MONTGOMERY COUNTY PLANNING DEPARTMENT
THE MARYLAND-NATIONAL CAPITAL PARK AND PLANNING COMMISSION

REVIEW TYPE: Preliminary Plan of Subdivision

APPLYING FOR: Resubdivision of Lot 6, Block A, in the Finlandia Subdivision into two lots. Two new one-family detached dwelling units are proposed.

PROJECT NAME: Finlandia
CASE #: 120090320
REVIEW BASIS: Chapter 50, Montgomery County Subdivision Regulations

Easement must be recorded Fire Department Access Review

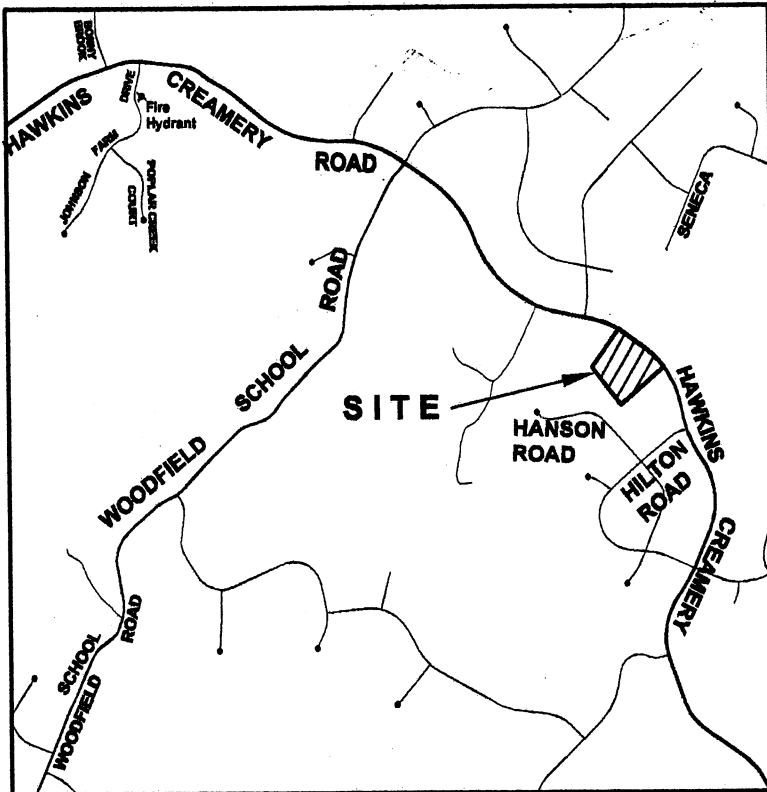
Review based only upon information contained on this plan. Does not cover unsatisfactory layout resulting from omissions, errors, or failure to clearly indicate conditions on this plan. Correction of such unsatisfactory layout to afford required access will be required if found upon inspection at installation.
